# COMMENTS FOR VALLCO SHOPPING DISTRICT SPECIFIC PLAN DEIR

Draft Environmental Impact Report SCH# 2018022021

JUNE 6, 2018

Figure 4: DEIR Heights

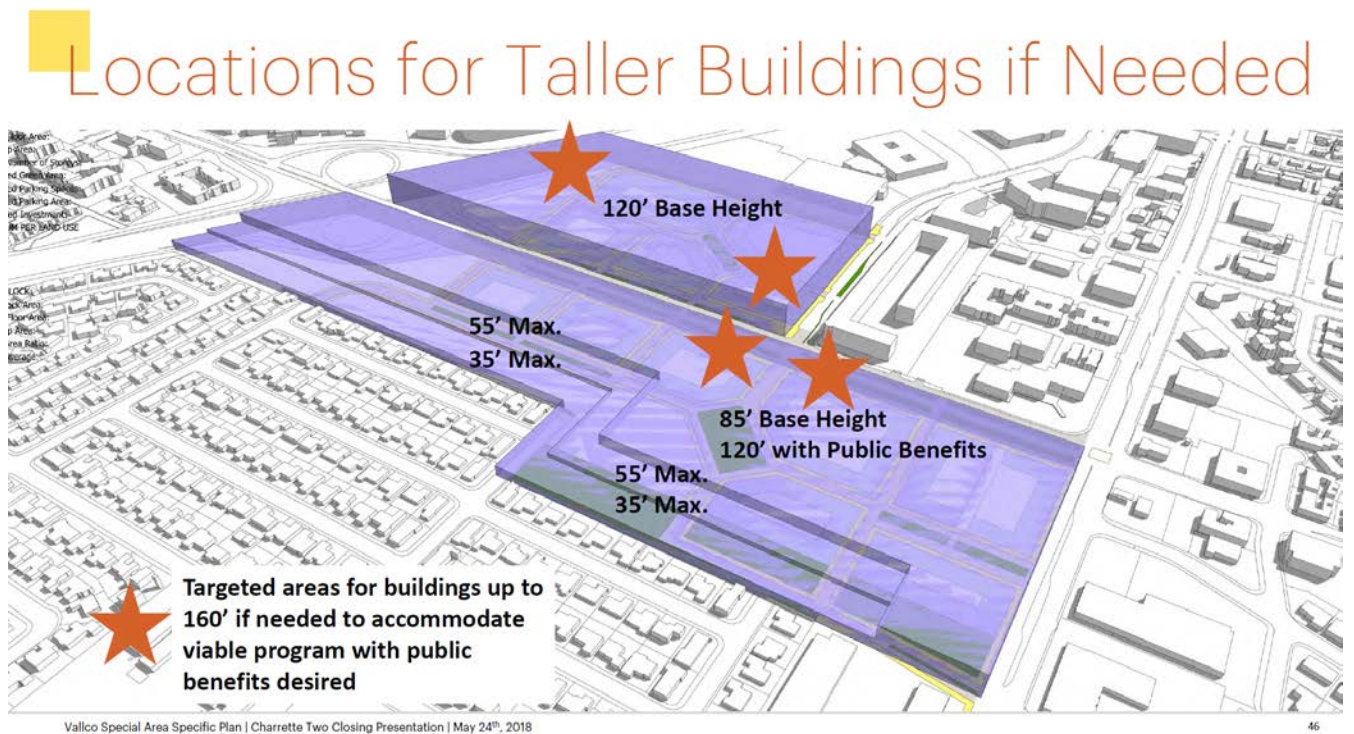
4. To add to the confusion as to what the project may end up being, the maximum height was also shown to be 294'. These height differences will cause different shadow and intrusion issues, such as privacy intrusion into Apple Campus HQ which may be a security risk at the corporate headquarters, guest discomfort at the outdoor swimming pool at Hyatt House, and the lack of privacy for the area homes and back yards. In Section 4.2.1 of the DEIR, heights are shown up to 165'.

Figure 10: Section from SB 35 Vallco Application

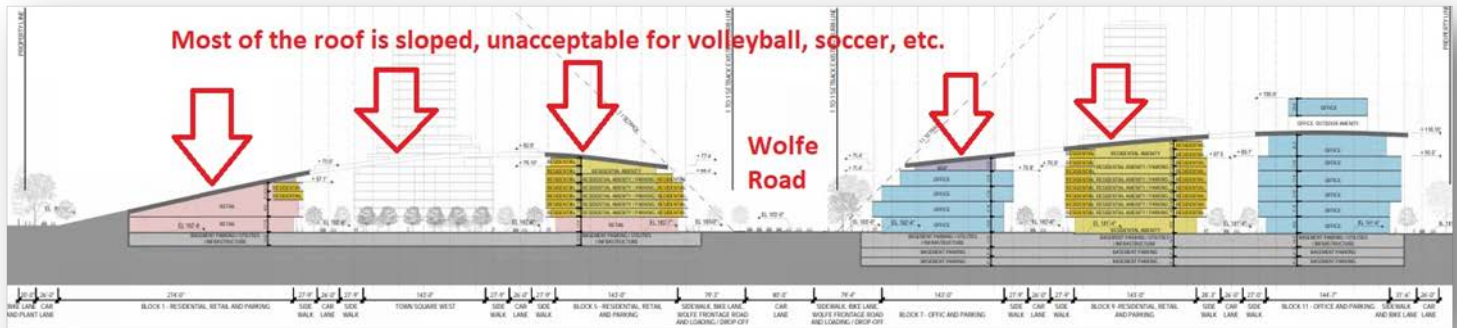
The 30 acre green roof is not park land acreage per the Municipal Code. While it may be considered a recreational area, the uses of such space are limited. Here is a cross section of the SB 35 plan roof:

Figure 25: AQI from BAAQMD

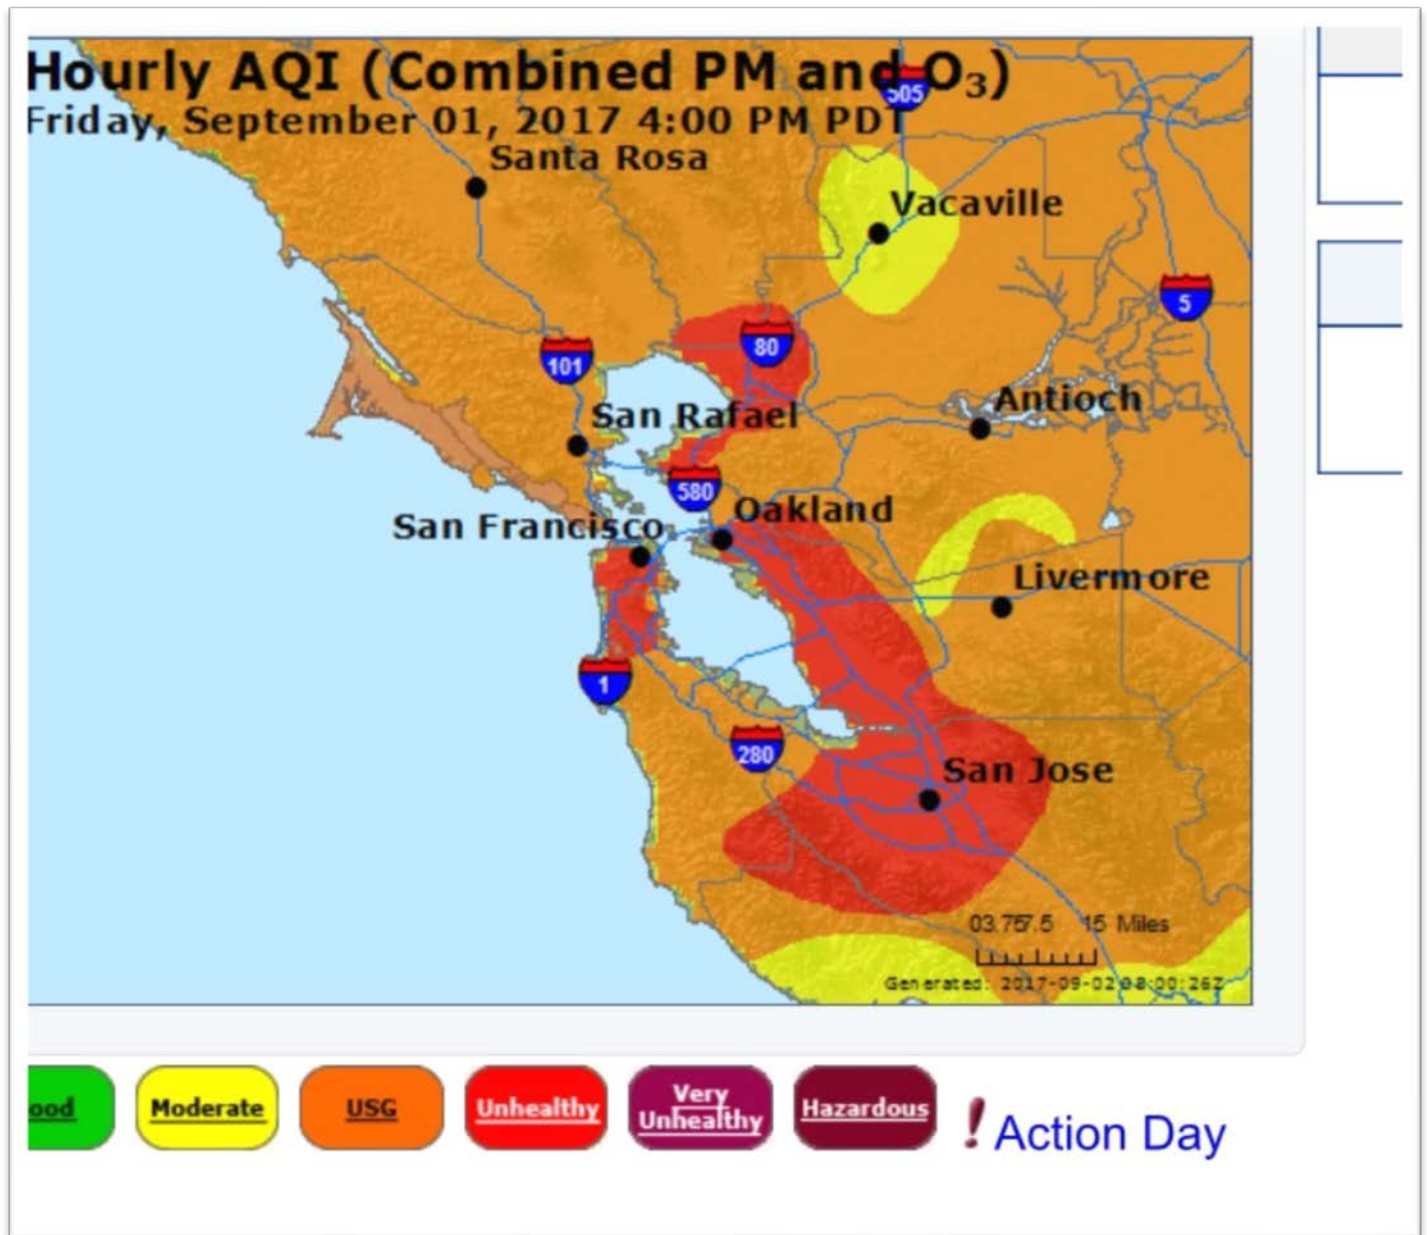
The cancer risk assessment is based on erroneous traffic studies and the air quality monitoring stations had old data from 2013 and/or were too far away to use data. The cancer risk needs to be recalculated. The amount of exposure time should reflect seniors not leaving the project area. The baseline air quality monitoring must be taken over an extended period with particular attention paid to the summer months when Ozone levels increase. Here is an example day when children would be playing outdoors, Ozone was the primary pollutant. Note these are regional amounts, and the increases along the freeways are not shown:

The I-280 freeway produces substantial TAC pollutant concentrations and the south bay is subjected to the entire bay area's pollutants which are converted to Ozone in the warm summer months. The DEIR failed to monitor air pollution for the site for any time period, and only modeled pollutants onsite. Fires are expected to be the new normal, bringing potential further impacts to the region's air quality.

Figure 42: Opticos Charrette #2

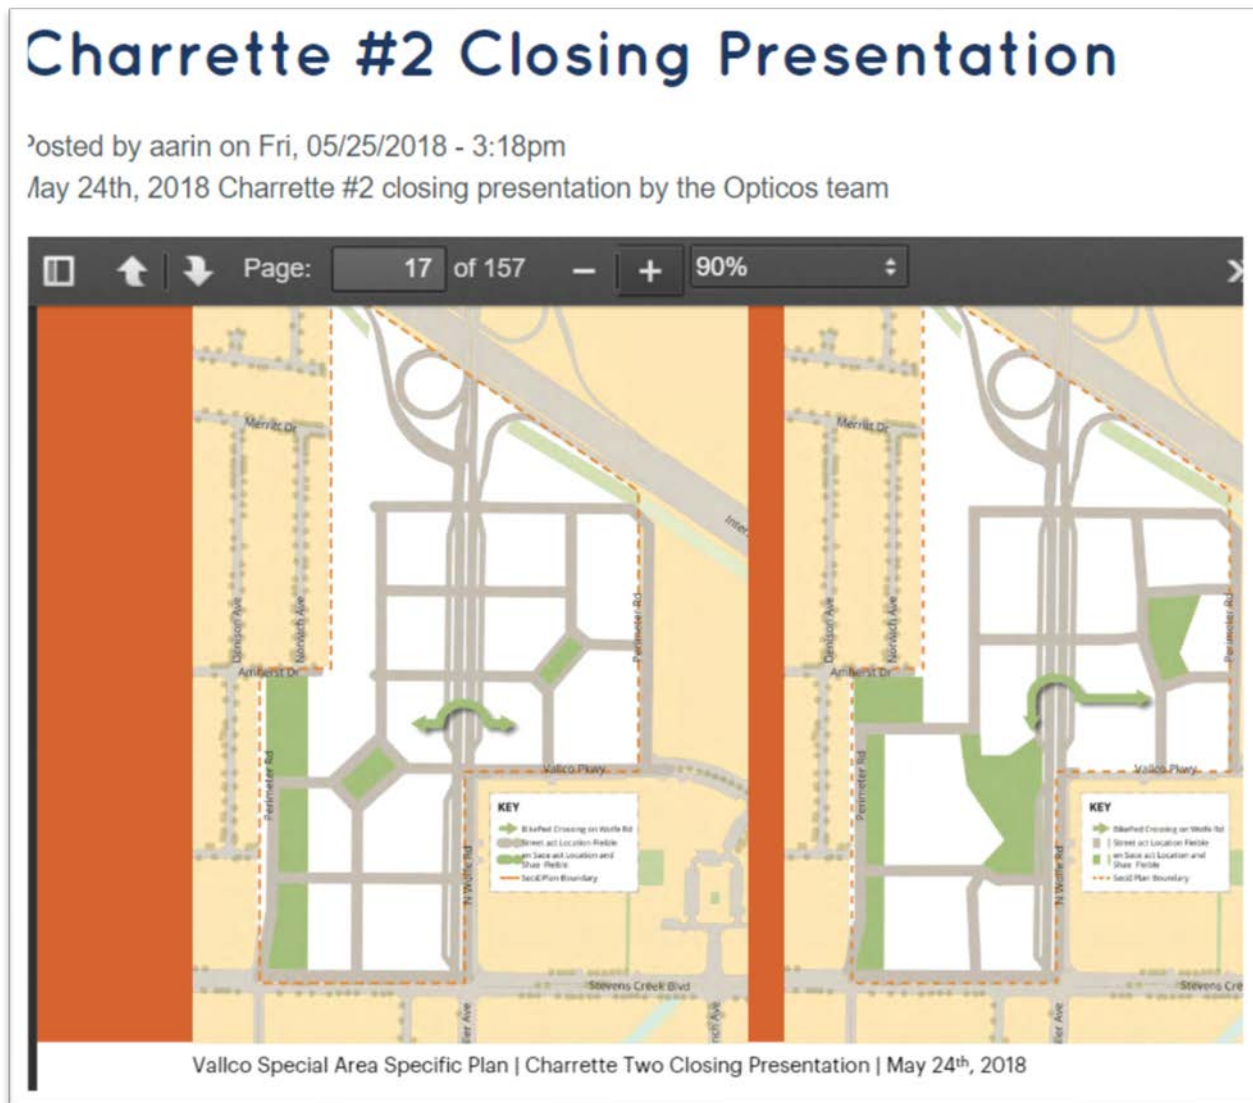
Charrette #2 Closing Presentation shows parks adjacent to back yards of single family residences. This may, combined with Perimeter Rd. noise exceed Municipal Code permissible sound levels. The DEIR does not adequately address this.

FIGURE 3.13-2

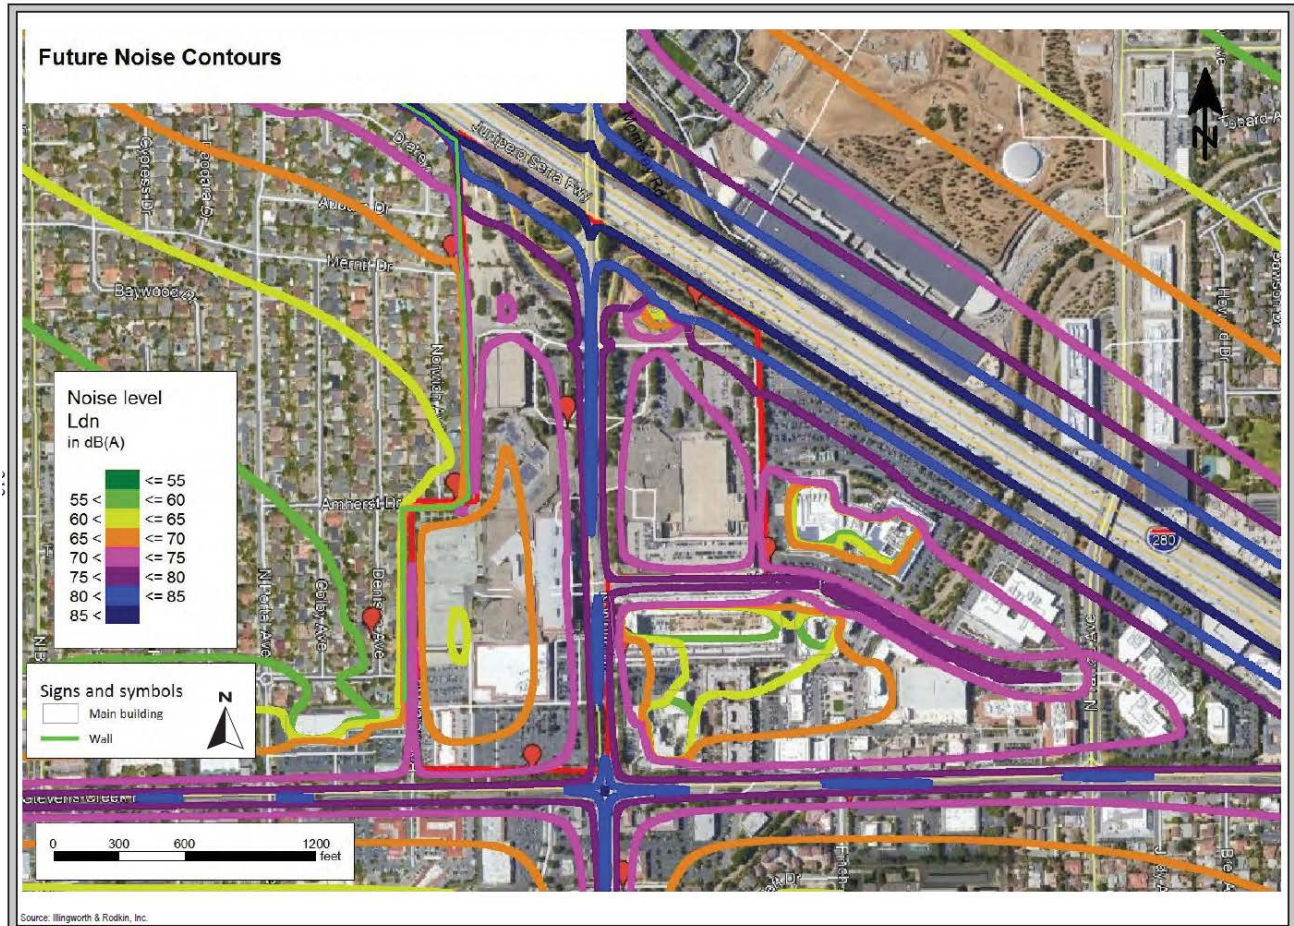
The Future Noise Contours map has some omissions regarding noise from the Perimeter Road, western edge park, and proposed amphitheater. The map has gross assumptions regarding what the plan would look like and ignores conditions on the roof which would result in a separate layer of mapping: One layer for ground level (ear level) and one level for the roof park to see if it meets park noise requirements.

The future noise contours for the project site exceed residential maximum levels according to the Cupertino Municipal Code 10.48.040.

Figure 52: Sample of local advertising showing higher employees per 1000 SF than studied

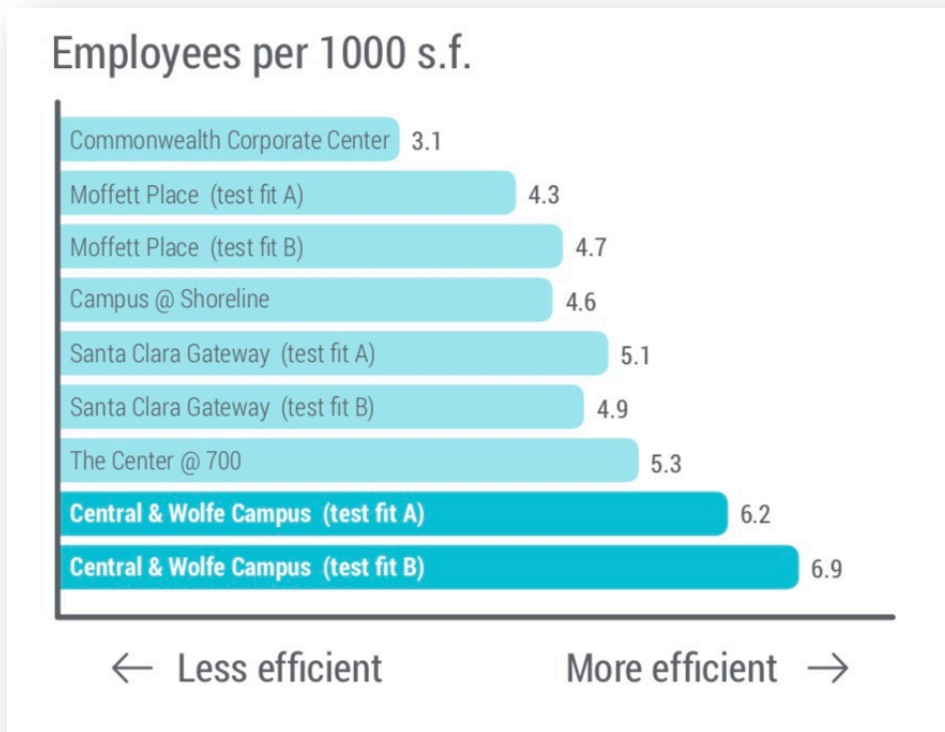
It is unclear, given that Apple Park has been occupying, how their (Apple Park) traffic has been assigned. For instance, there were traffic counts in May, 2017 which would reflect thousands of trips by construction workers to the site which would likely have been coming from the I-280 and east bound AM and westbound PM. There were also traffic counts in January, 2018, which would perhaps now show a few hundred Apple tech workers who would presumably be coming from other areas along with continued construction workers. As of March, 2018 approximately 6,000 employees were at Apple Park out of the expected 14,200. There have been many requests of the city to wait until Apple Park fully occupies to perform traffic counts. Main Street Cupertino was also under construction during May, 2017 and those construction workers would also be impacting the counts. There have been several intersections under construction, including the Calvert/I-280 project and Lawrence Expressway/I-280 exit project. These multiple projects have rerouted traffic and altered the makeup of drivers into artificial patterns not reflected in the study. What the traffic counts show, is what the area traffic is like with major construction underway.

Traffic impacts, while significant and unavoidable with mitigation is underestimated.
